eSet 2003 JD Installation Modification

A Solution For 2003 Pro Series Planters with Metal Mounting Brackets

Fig. 1

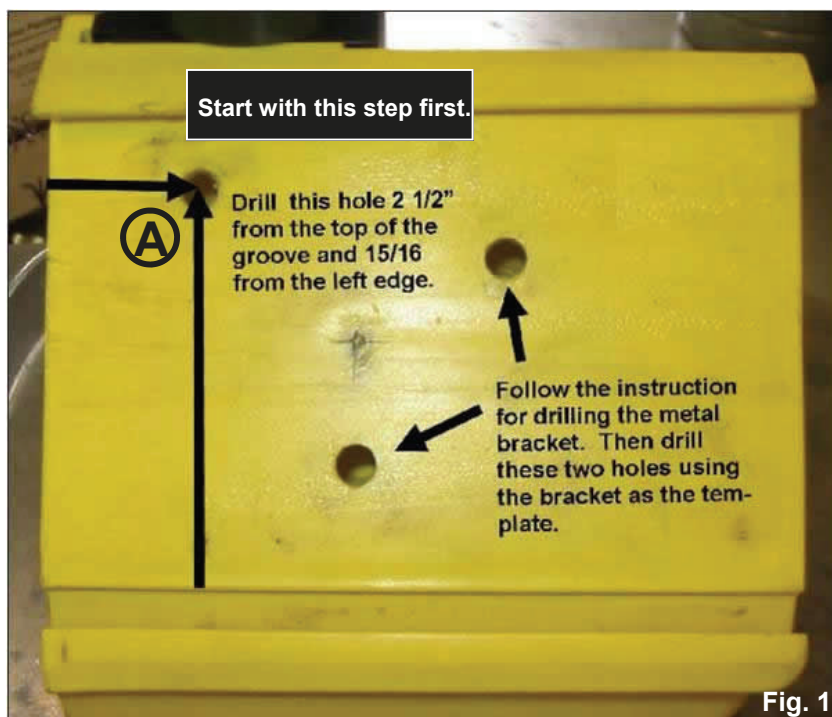
Start with the ProFlow Hopper and drill a hole in the upper left corner first. **A** (fig 1) Next, drill the two new holes in the bracket as shown in **B** (fig 2). Then mount the bracket to the hopper by inserting a bolt through the existing hole in the bracket and the new hole **A** you drilled into the hopper. Align the bracket and hopper so the top of the bracket is parallel with the top lip of the hopper. Use a C clamp to secure the bracket to the hopper. Tighten the first bolt. Now use the two new holes on the bracket **B** as a template to drill into the hopper. Once these holes are drilled, simply put the bolts through these new holes and tighten.
